## **NOTICE OF PUBLIC MEETING**

**Governmental Body: Van Meter Planning and Zoning Commission**

CITY OF VAN METER, IOWA  
PRELIMINARY PLAT - HILLTOP  
FINAL PLAT - HILLTOP  
REVIEW COMMENTS

CITY OF VAN METER, IOWA  
VAN METER COMMUNITY SCHOOL DISTRICT  
EAST ATHLETIC CAMPUS  
PRELIMINARY SITE PLAN  
REVIEW COMMENTS

# PRELIMINARY PLAT HILLTOP VAN METER, IOWA

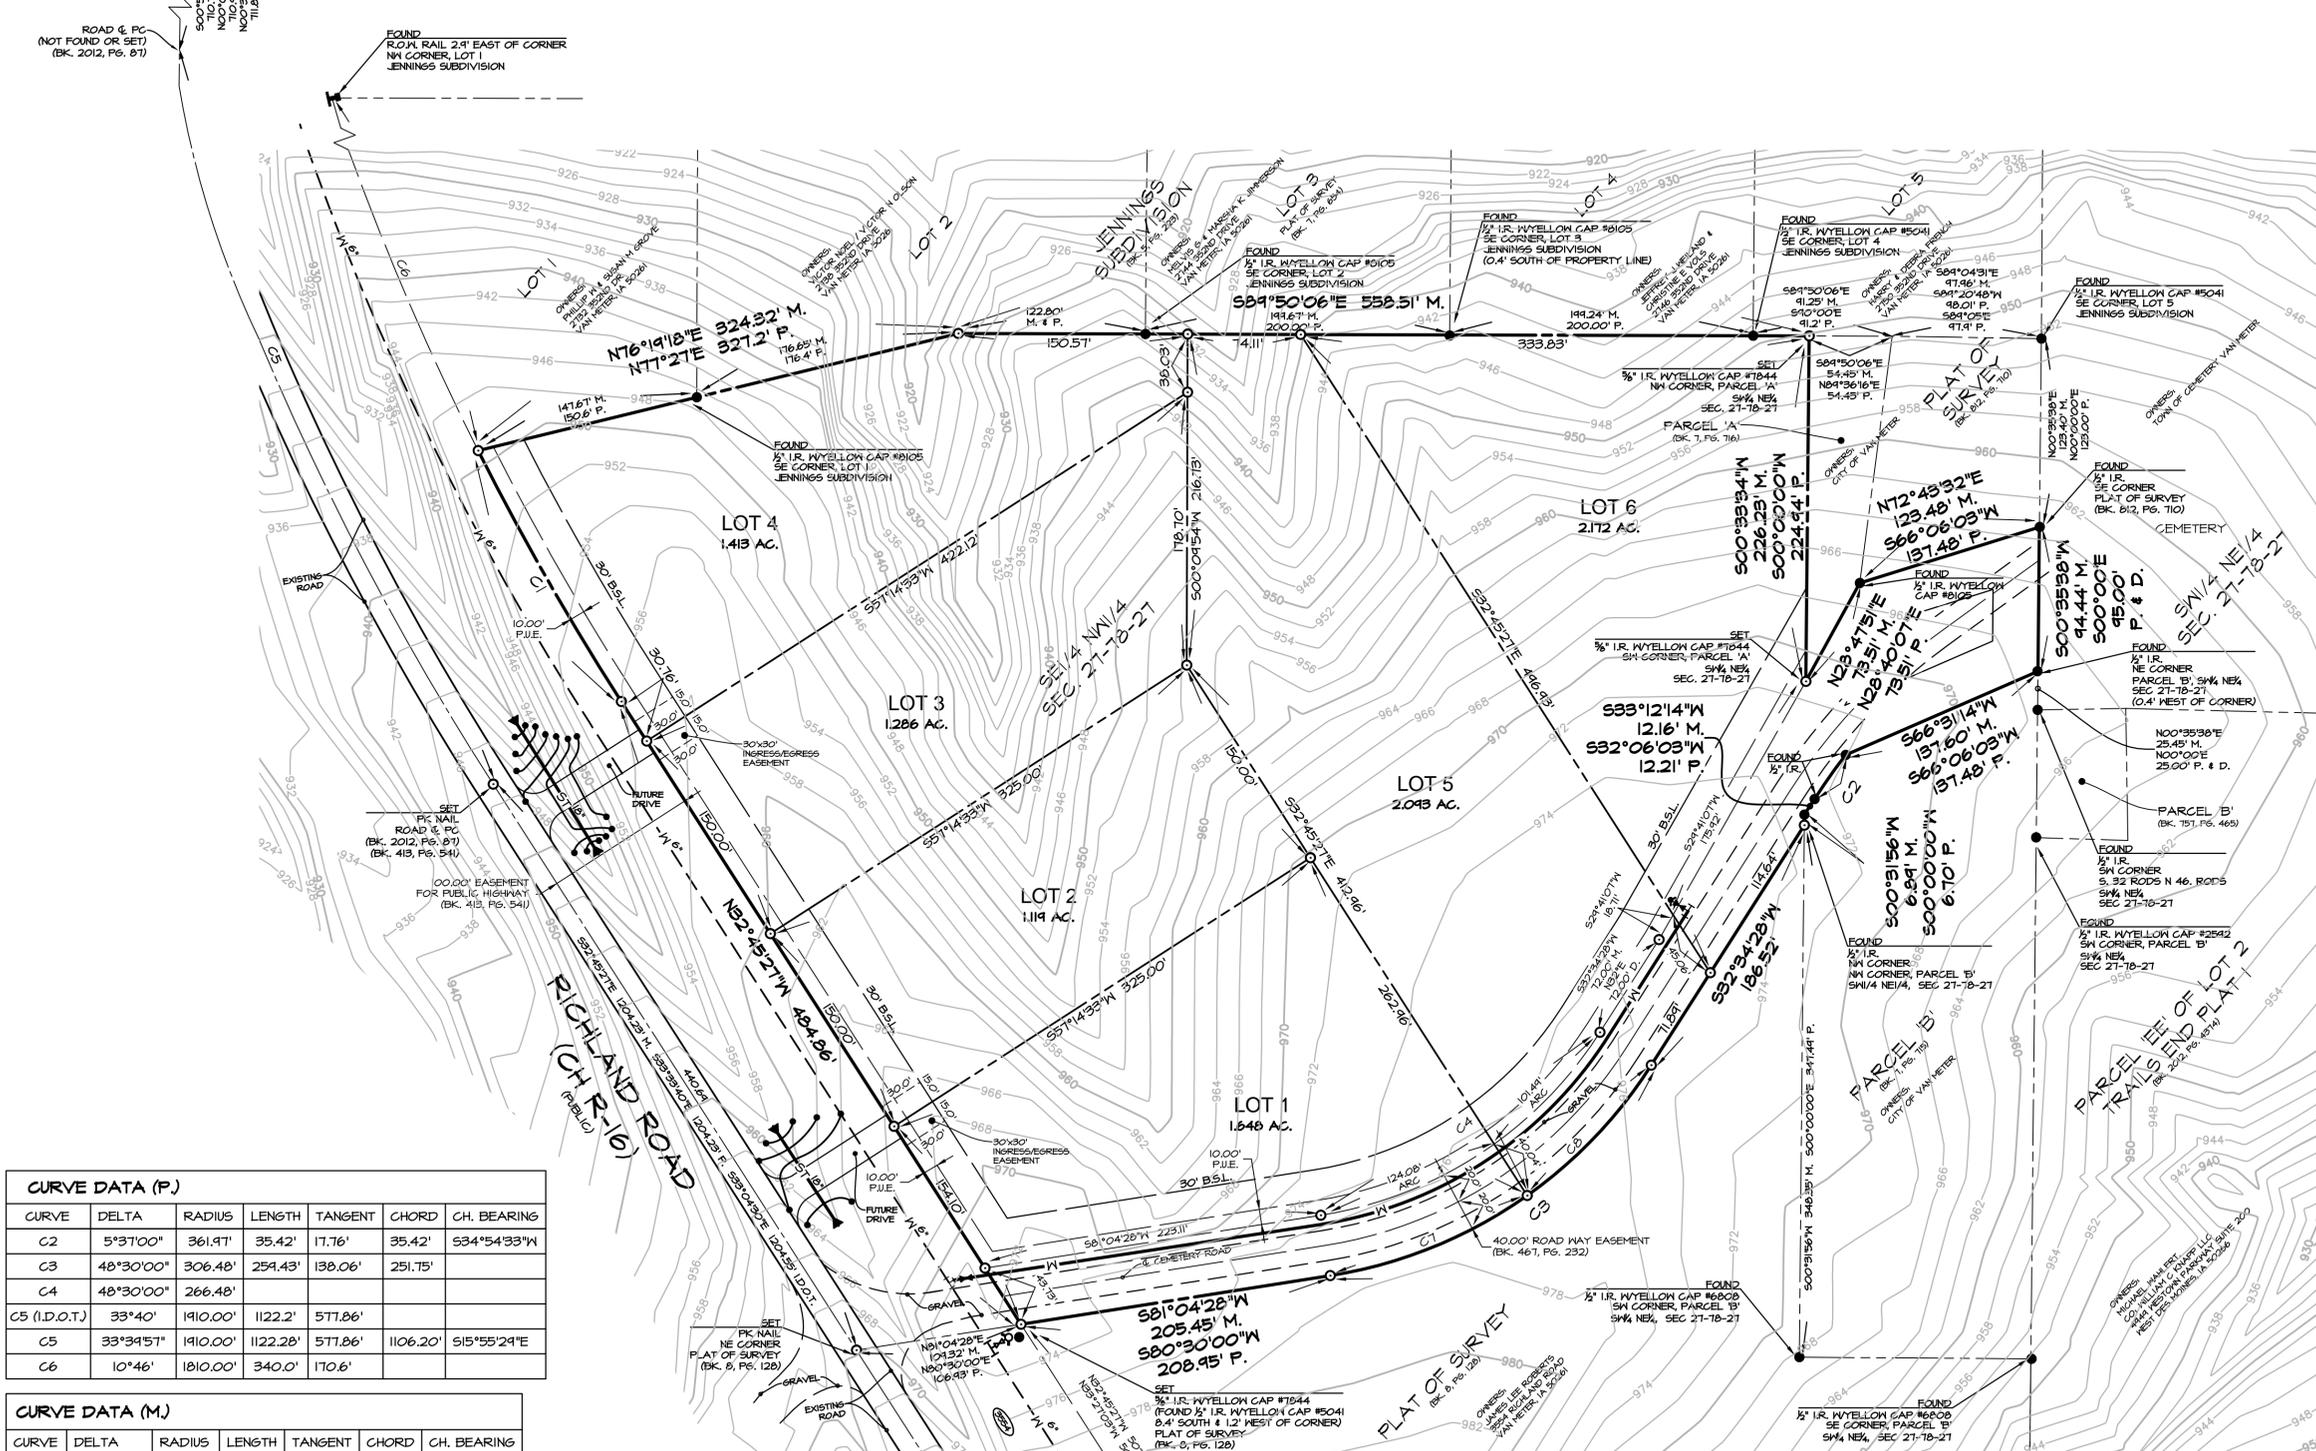
1. The preliminary plat shows the existing 6-inch water main located along the east side of Richland Road. The location of the water main was generally taken from the 2005 construction plans.
2. Both the preliminary plat and final plat note a 2005 water main easement extending 15 feet either side of the water main, wherever it is located. It is believed the easement is for the 6-inch water main located along Richland Road. The property description of Hilltop appears to exclude the road right-of-way. The water main is located within the right-of-way of Richland Road. Although there is a reference to the water main easement the water main easement probably does not impact the property.
3. The preliminary plat shows the extension of a water main along the north side of cemetery road to the southwest corner of Lot 6. A fire hydrant is shown to be located at the end of the water main.

4. The preliminary plat does not show the size of the water main extending along the cemetery road. It is suggested this water main be constructed of 8-inch diameter pipe.

It is recognized the water main would connect to the 6-inch water main on Richland Road. The City's long term plan for the water distribution system would anticipate the construction of a parallel or larger water main on Richland Road to improve the interconnection between the high pressure system and low pressure system. If the City constructs a parallel water main it would be preferable if the water main on the cemetery road would be 8-inch diameter to maximize the potential fire flow to the hydrant on Lot 6.

5. The preliminary plat shows an existing hydrant located on the south side of the cemetery road and the new hydrant located on Lot 6. The preliminary plat does not show the existing hydrant located near the northeast corner of Richland Road and 352<sup>nd</sup> Drive. The existing hydrant is located on the low pressure side of the interconnection between the high pressure system and low pressure system. Although this hydrant on Richland Road could be used to provide hydrant coverage for Lot 4, it is not recommended this hydrant be relied on for coverage.

The hydrant is located immediately north of the pressure sustaining valve. If this hydrant were used for fire fighting it would almost certainly reduce the pressure and cause the pressure sustaining valve to open. Depending on the fire flow at the hydrant, causing the pressure sustaining valve to open could result in very elevated pressures in the northerly part of the City. The primary purpose for this hydrant is to provide flushing and testing for the pressure sustaining valve.

It is requested an additional hydrant be added to the 6-inch main near the northwest corner of Lot 4 to provide adequate fire coverage and to avoid use of the test fire hydrant near the pressure sustaining valve.

6. The preliminary plat does not show sanitary sewer. The City and developer have reached a tentative agreement on the installation of a sanitary sewer along the east side of Richland Road extending to the south edge of the cemetery road. It would be preferable if the preliminary plat would conceptually show the sanitary sewer along an alignment approximately 20 feet west of the water main.
7. No stormwater drainage improvements are proposed as part of the preliminary plat.

8. The area of Lot 1, Lot 2, Lot 3 and Lot 4 generally drains toward the swale that extends northerly through the central portion of these four lots. Stormwater runoff is generally northerly toward the property located at 2738 352<sup>nd</sup> Drive.

9. Stormwater drainage for Lot 5 is northerly to a natural swale that extends into the property at 2744 352<sup>nd</sup> Drive. The stormwater runoff from Lot 6 is generally northerly and would flow onto the property at 2746 352<sup>nd</sup> Drive.

11. No transportation improvements are proposed as part of the project.
12. The preliminary plat shows a common driveway serving Lot 3 and Lot 4 and a common driveway serving Lot 1 and Lot 2. Although the common practice is to have dedicated driveways to each lot the traffic volume on Richland Road would appear to justify the common drive as a means of reducing the number of driveways and traffic conflict points on Richland Road.

13. The preliminary plat shows continued use of the cemetery road. The cemetery road is located in a 40-foot roadway easement along the southerly boundary of Lots 1, 5 and 6.

14. The City of Van Meter currently requires all lots in a new residential subdivision to have frontage on a public street. Lots 1, 2, 3 and 4 meet this requirement. Lot 5 and Lot 6 that use the existing cemetery road would not meet this requirement.

As part of the approval of the subdivision the City will need to determine if it will waive this requirement, or if the City will enforce the requirement for frontage on a public street. If the frontage requirement is mandated the preliminary plat and final plat as now configured would not be approveable.
15. The preliminary plat shows a 10-foot public utility easement adjacent to the westerly lot line of Lots 1, 2, 3 and 4 adjoining Richland Road.
16. The plat shows a 10-foot public utility easement on Lots 1, 5 and 6 located immediately north of the 40-foot roadway easement.

# FINAL PLAT HILLTOP VAN METER, IOWA

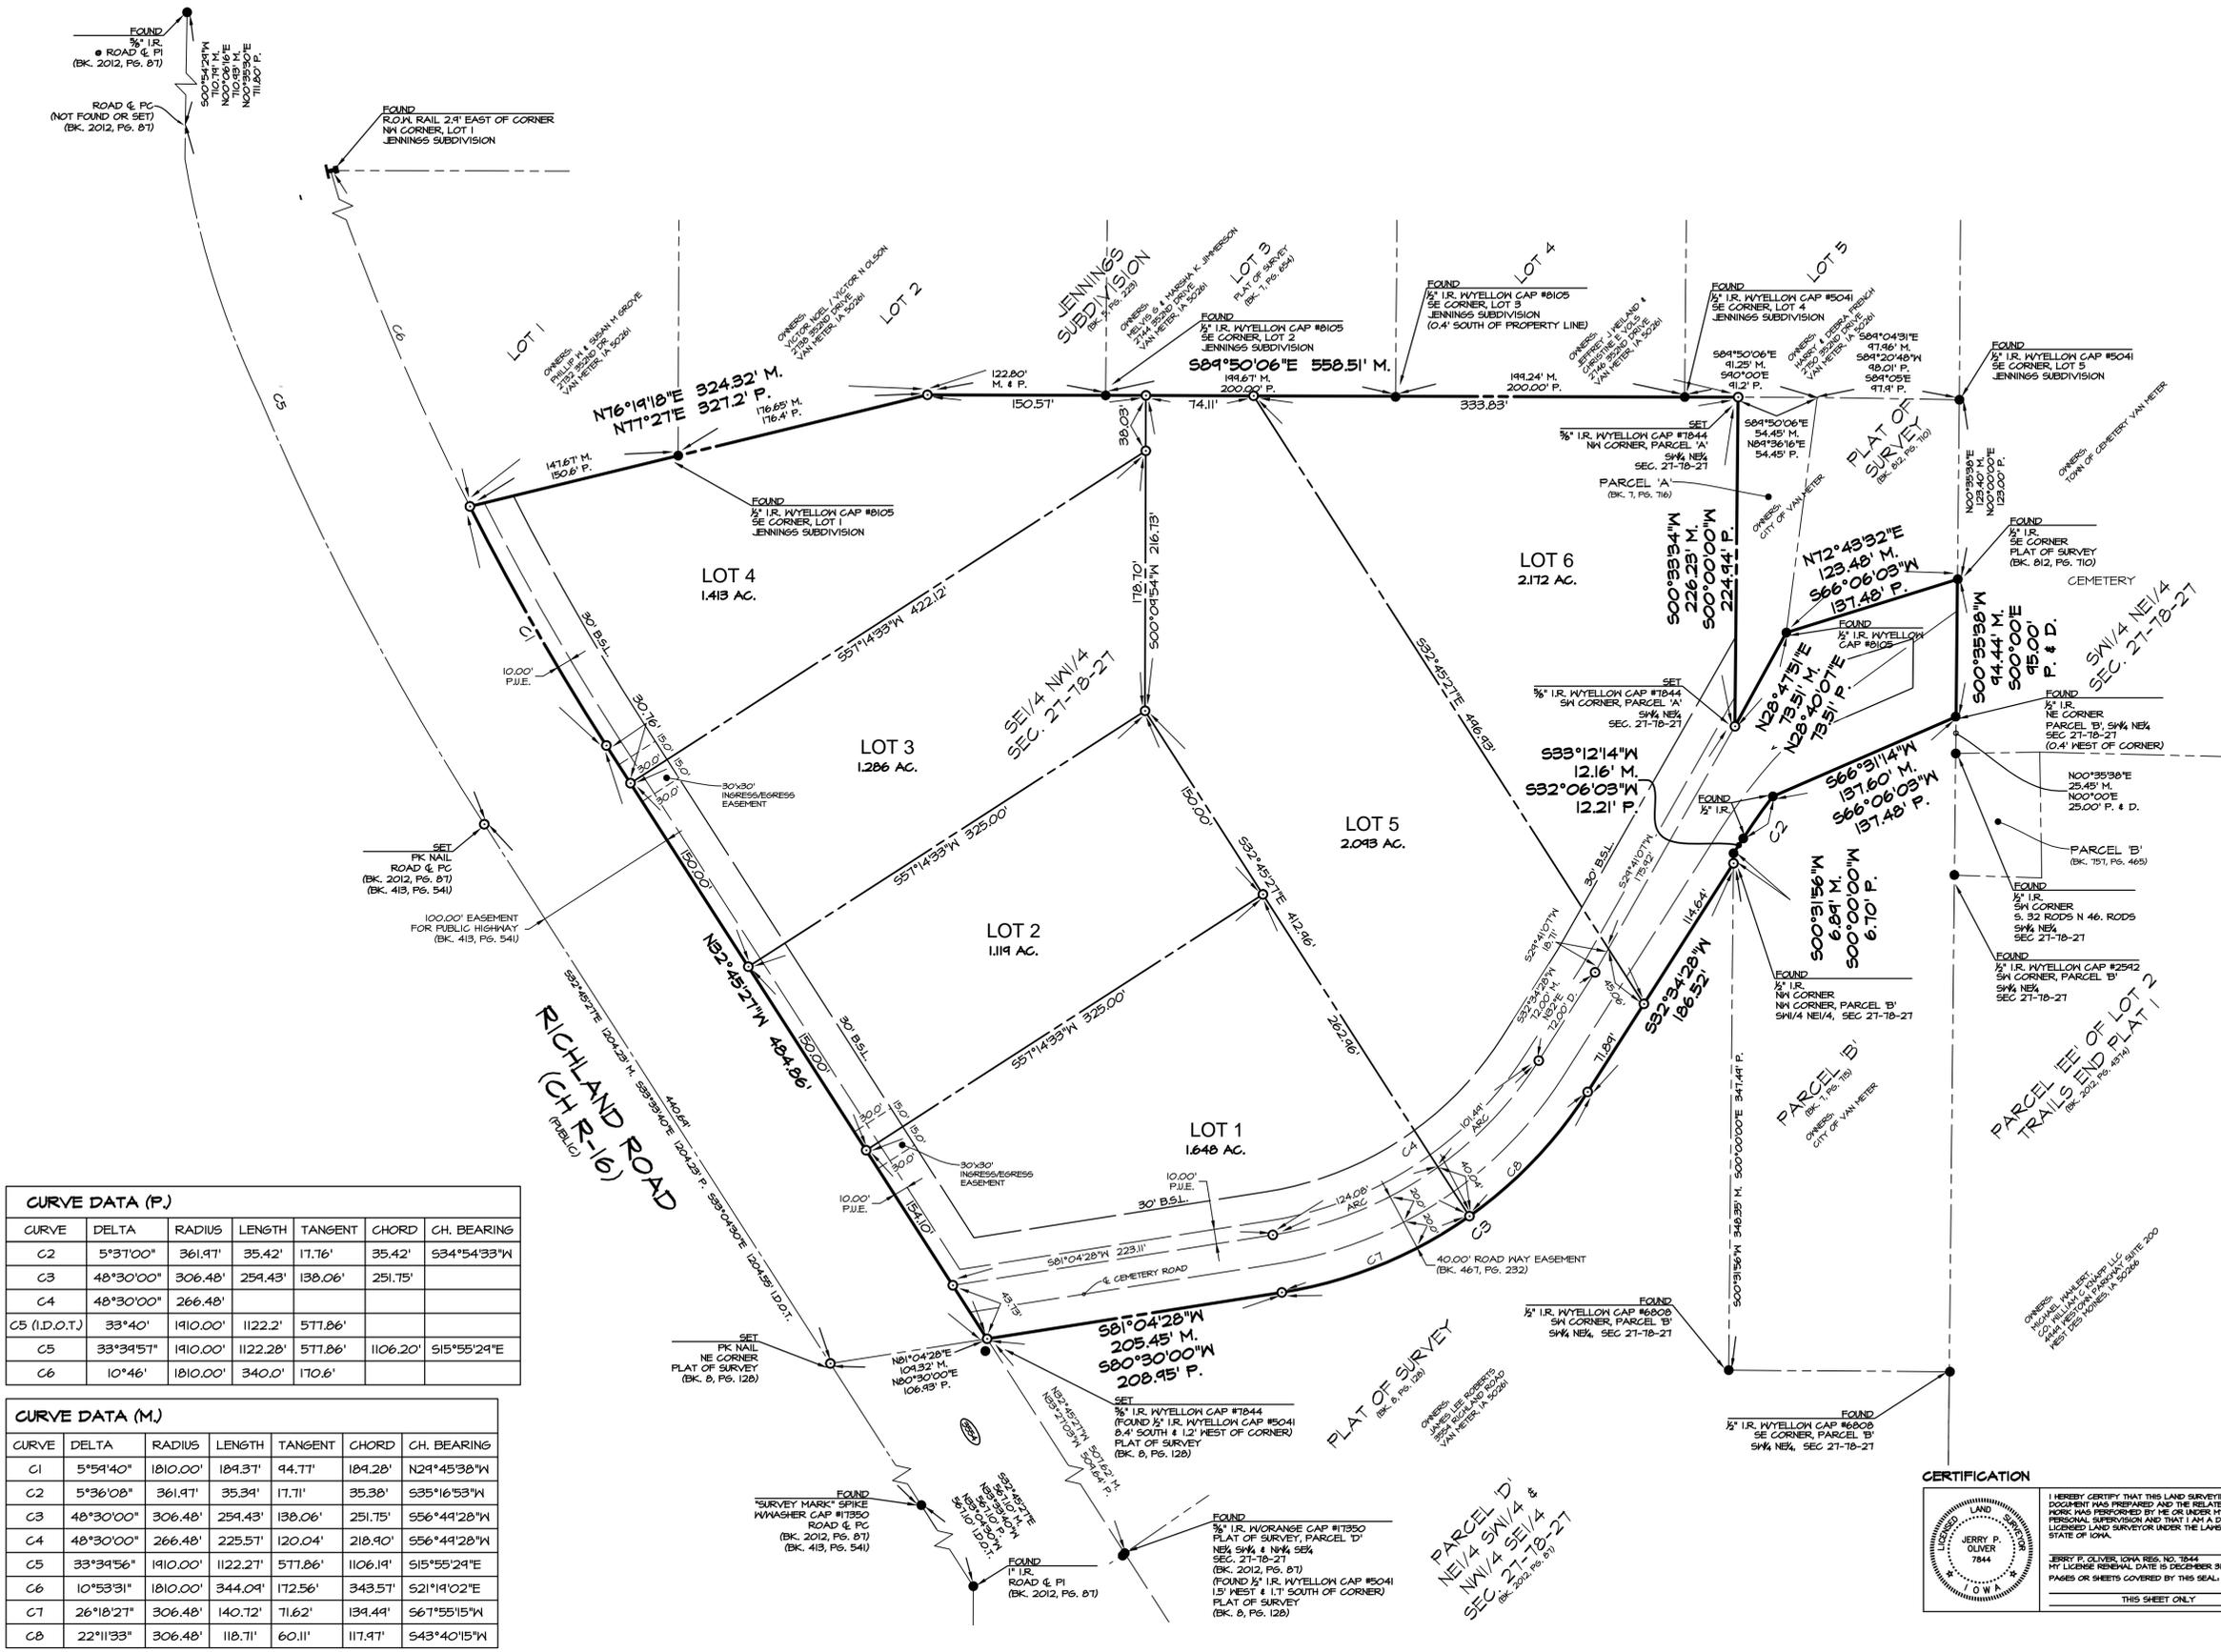
17. It appears the water main is located within the roadway easement rather than the public utility easement. Given recent court decisions concerning the use of roadway easements for non-roadway purposes, the writer believes it would be preferable for the final plat to show an easement for the water main.
